Errata 1

Manual: 24107

Manual Index: 01

Figure 4-4: Configuration Diagram for All Channels, Common ‘Plus’

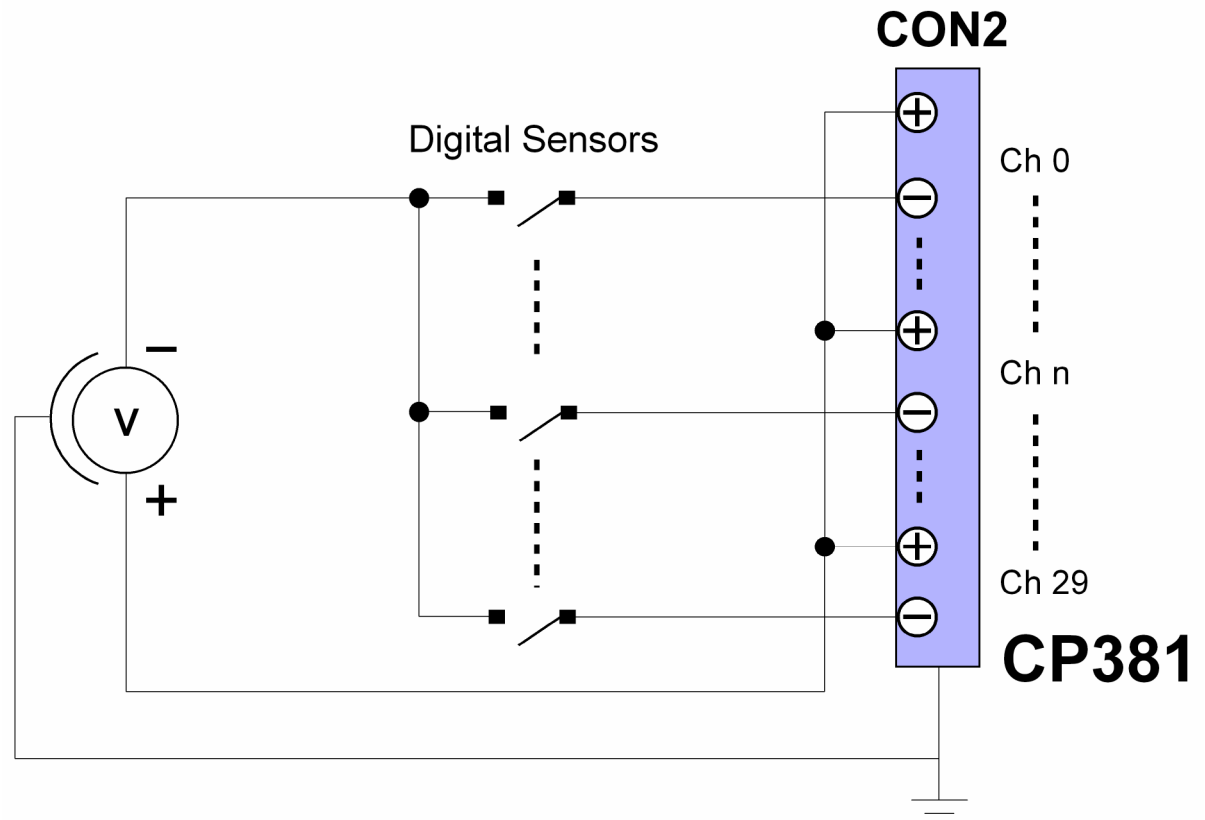
3. Reference: Page 4 - 5, Chapter 4.2.3, Figure 4-4

The referenced information (figure title) is revised as follows.

The text:

Figure 4-4: Configuration Diagram for All Channels

is changed to read:

Figure 4-4: Configuration Diagram for All Channels, Common ‘Plus’

The referenced information (figure) is superseded by the following replacement figure (the polarization of the voltage source is changed):
